MP ref: M2258
DA ref: MCU24/0092
QA: hw.sj.mc

Re: Information Request Response
Development Application seeking a Development Permit for Material Change of Use – Health Care Services (Medical Centre Extension) and Shop (Pharmacy) on land described as Lots 56 and 57 on RP703491 and located at 110-112 Bowen Road, Rosslea

Information Request

Application no:	MCU24/0092
Assessment no:	1806044
Proposal:	Health Care Services (Medical Centre Extension) and Shop (Pharmacy)
Street address:	110 Bowen Road ROSSLEA QLD 4812 112 Bowen Road ROSSLEA QLD 4812
Real property description:	Lot 57 RP 703491 Lot 56 RP 703491
Applicant's reference:	M2258

Figure 6. 2025 Background Traffic AM and PM Peak Hour Traffic Distribution- Bowen Road/Viles Street Int.

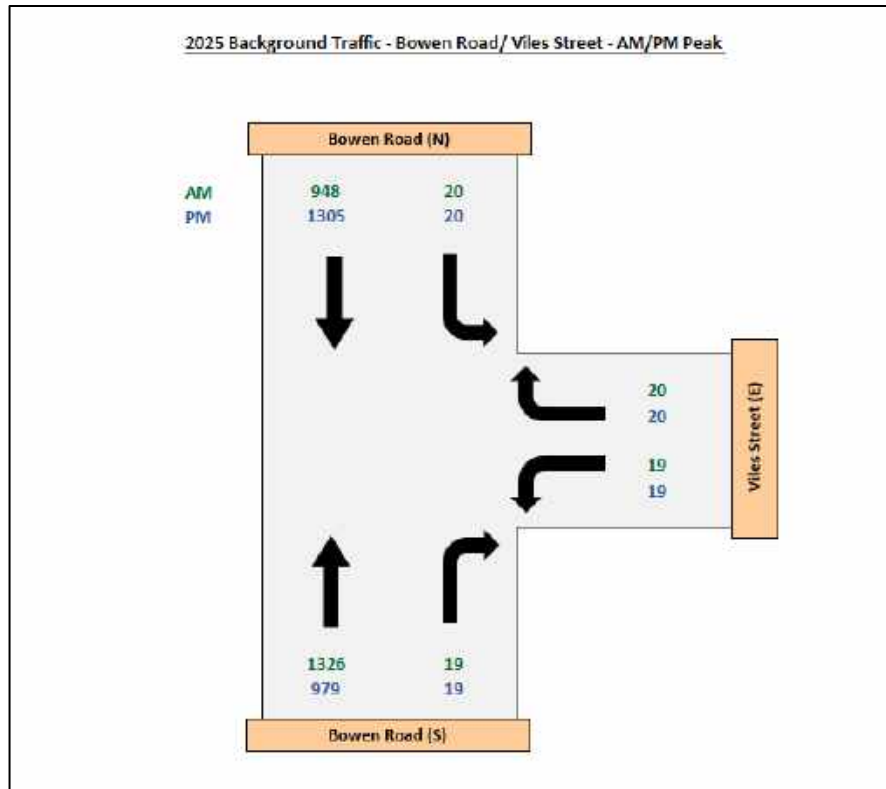
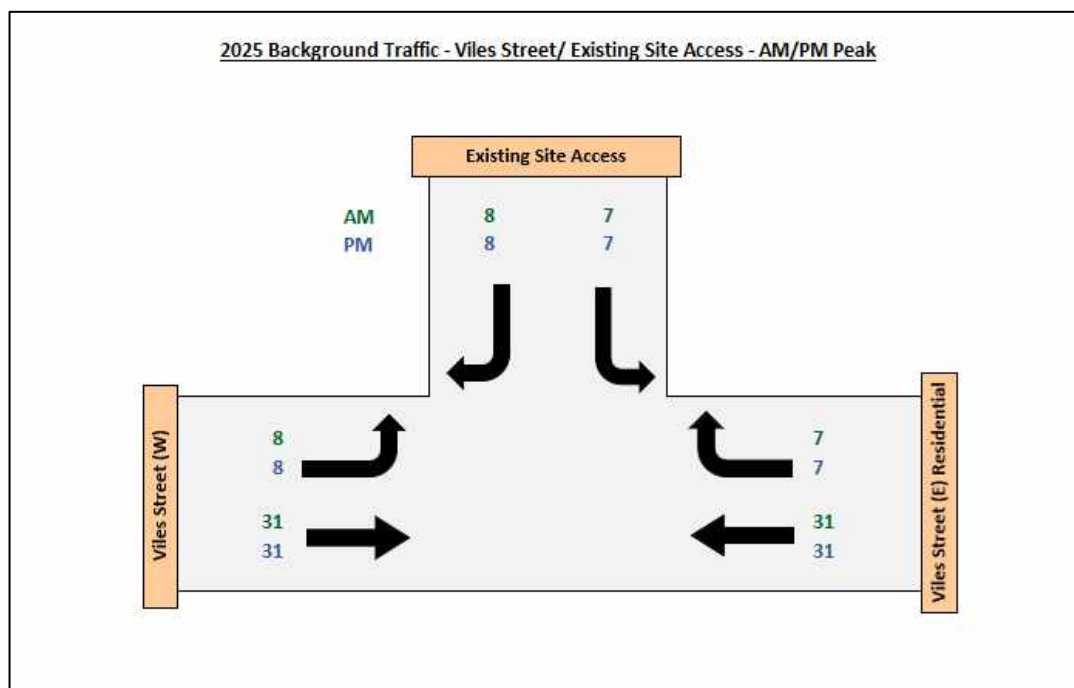
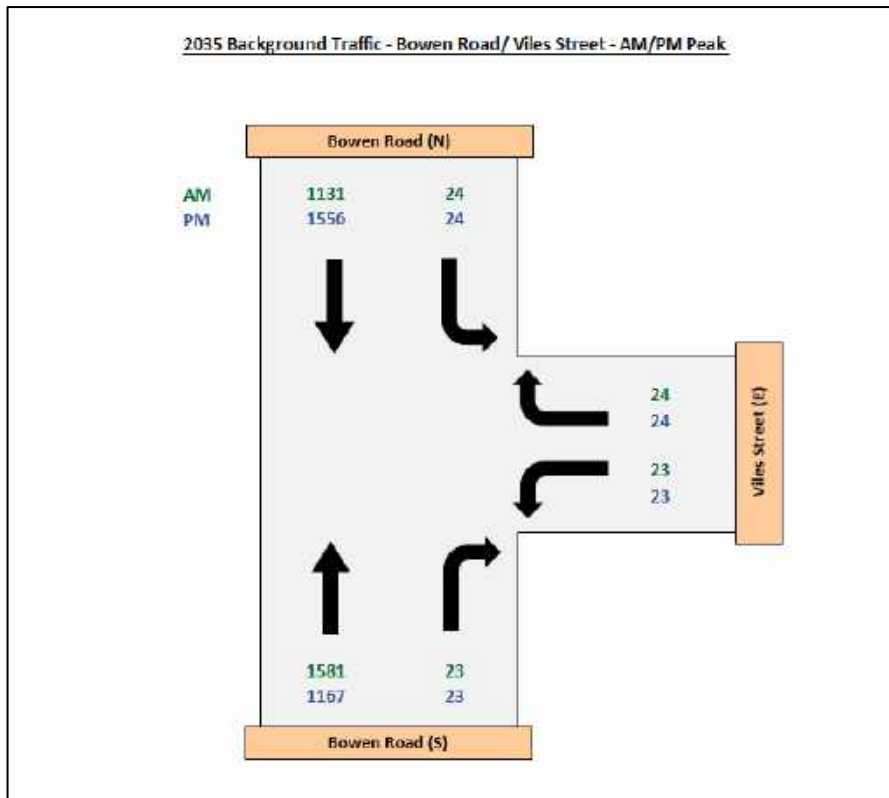
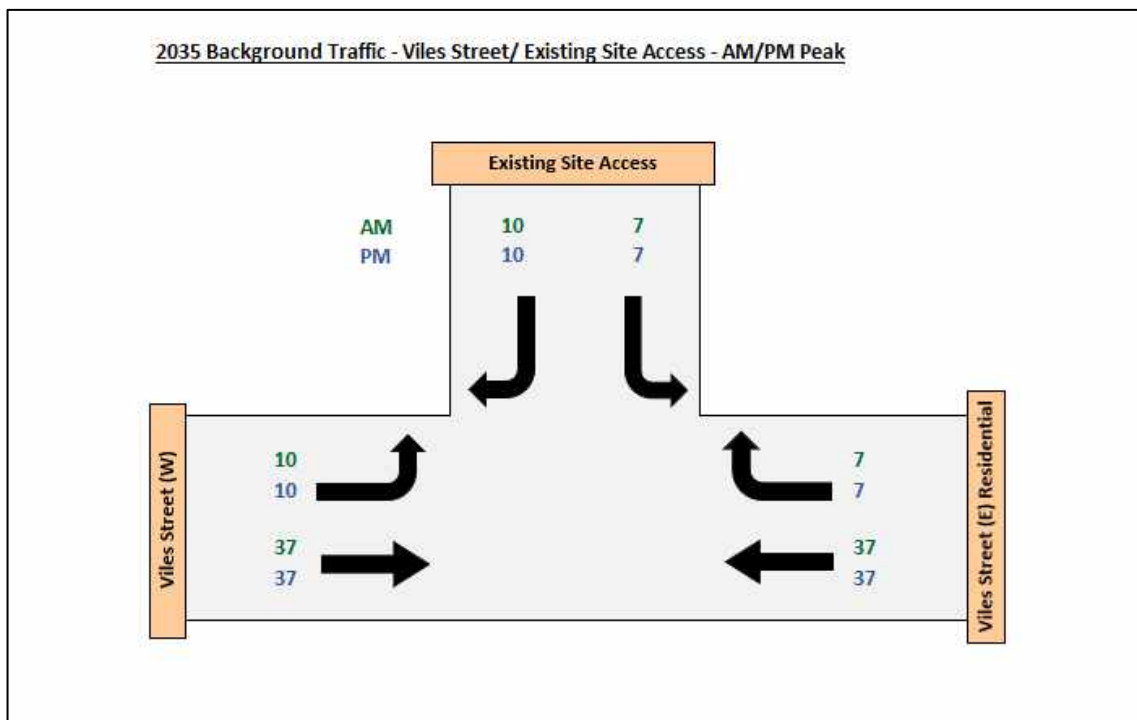
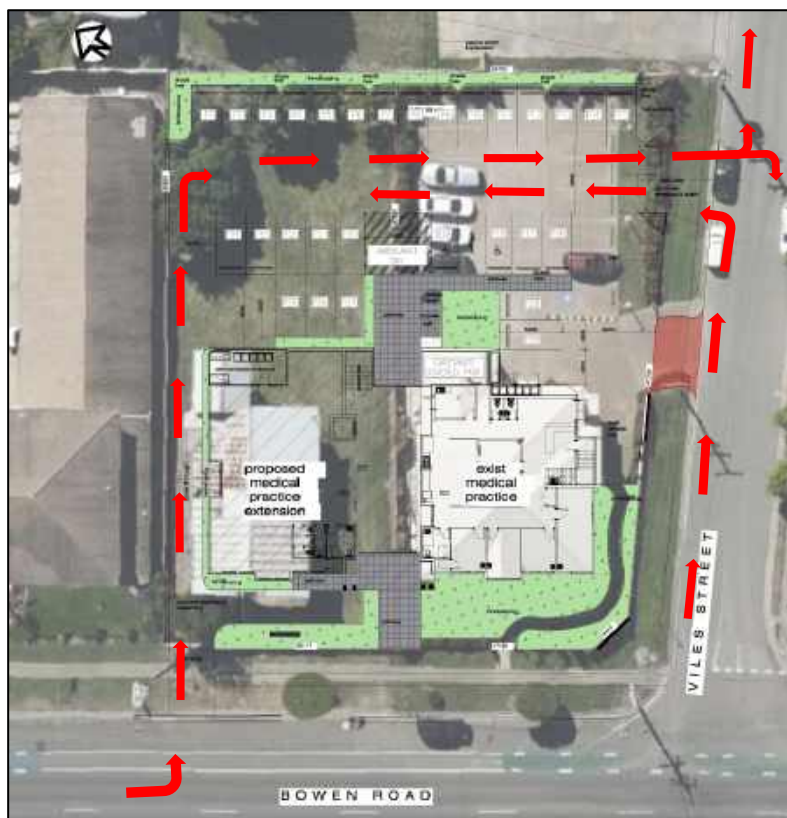
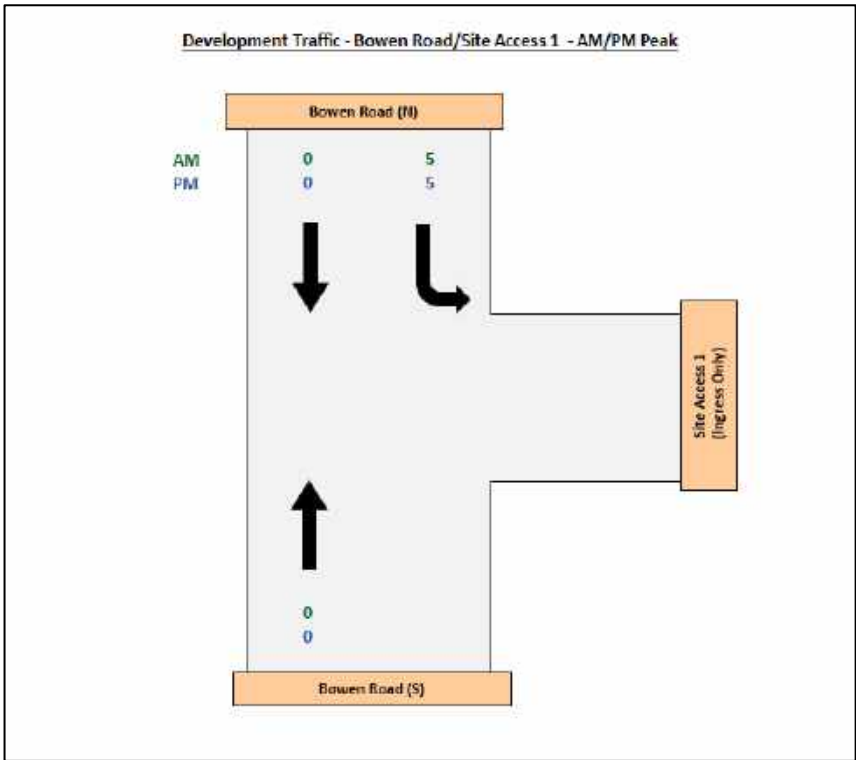
- All the extracts (Figures) in the TIA are of very low quality (particularly, Figures 6-11). These extracts are crucial as they represent the traffic data and traffic distribution. Due to the image quality Traffic data could not be reviewed satisfactorily. These extracts are therefore required to be updated.

Item	Suggested Response
Item 4 Traffic Impact Assessment	<p>This item requested the Applicant provide a revised Traffic Impact Assessment (TIA) report demonstrating that existing transport infrastructure is appropriate, in terms of safety and efficiency, for the expected traffic generated by the development.</p> <p>In response to this item, Langtree Consulting Engineers have revised the TIA to respond to this item, refer to Attachment 4. This revised TIA has assessed the impact of the proposed development on the existing road network including at intersections and accesses, including operational performance and road safety.</p> <p>The impact of the proposed development on the road network has been analysed using procedures set out in Austroads, Australian Standard AS2890, Parking facilities and in TMR's Guide to Traffic Impact Assessment. Whilst the level of performance of the left and right turn out from the Viles Street currently shown as operating at a LOS F, assessment has found that there is no significant worsening of the operational performance of the surrounding road network as a result of the proposed development. The turn warrant checked shows that the road networks has already implementing the recommended turn warrants for right turn in which is an CHR(s). However, the AUL(s) warranted turn treatment for left turn in is not existing and as such AUL(s) is to be implemented. A proposed AUL(s) have been provided. The proposed sight access has adequate SSID and ASD. Pedestrian sight distance was assessed and found to have suitable safe pedestrian sight line provided that landscape along the sight line are low level planting.</p> <p>In conclusion, the proposed development accesses have been found to be adequate and no significant adverse impact on the operational performance or safety of the surrounding road network has been identified thus, no other mitigation measures have been deemed necessary.</p> <p>It is considered that the above response and amended TIA, sufficiently address this item.</p>
